# HVAC Air Outlet Upgrade

<b>Classification</b>	Repair Bulletin	<b>Section/Group</b>	18 - Thermal Management	<b>Country/Region</b>	United States
<b>Year</b>	2012	<b>Model</b>	Model S	<b>Version</b>	All

This Service Bulletin supersedes SB-13-18-001 R2, dated 30-Jan-14. Each content change is marked by a vertical line in the left margin. Discard the previous version and replace it with this one.

Figure 1

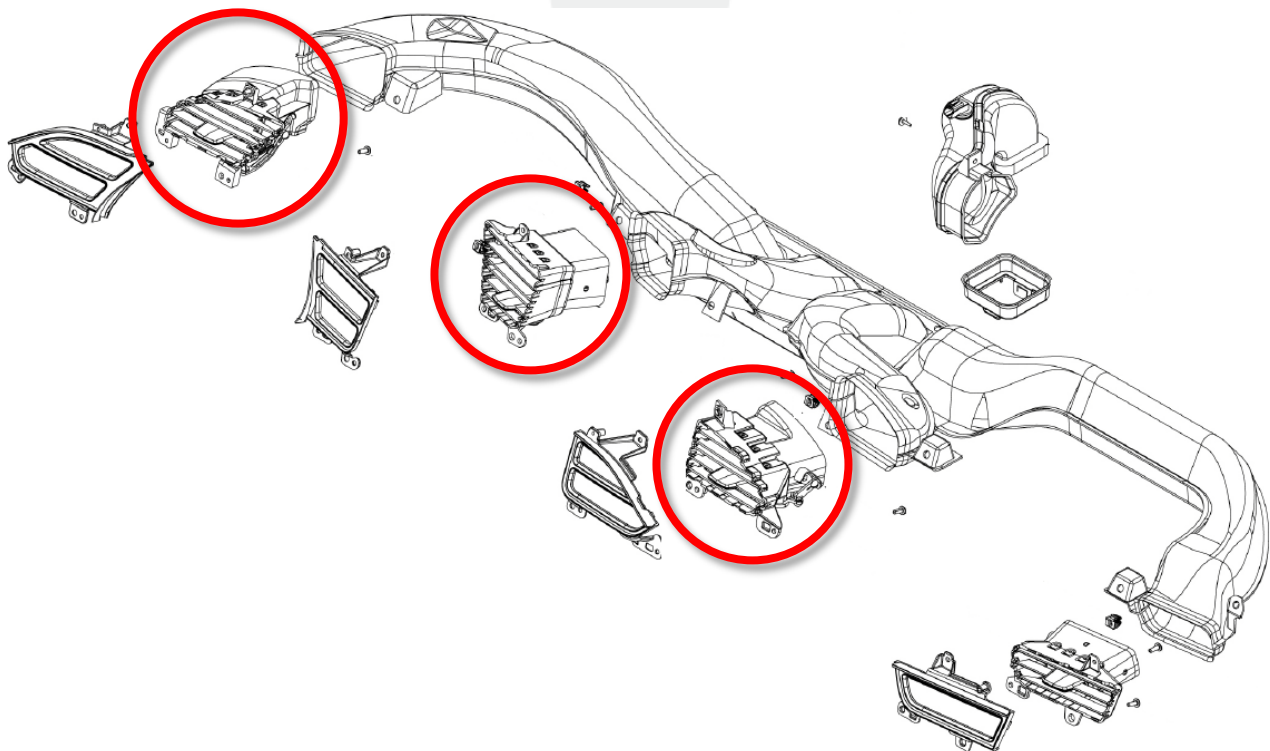
HVAC air outlets that reduce buzzing and rattling are now available.

Upon complaint, replace the outer LH air outlet, inner LH air outlet, and inner RH air outlet on all cars within the affected VIN range (Figure 1).

1. Replace the outer LH air outlet (refer to Service Manual procedure 14053102).
2. Replace the inner LH air outlet (refer to Service Manual procedure 14053202).
3. Replace the inner RH air outlet (refer to Service Manual procedure 14053402).
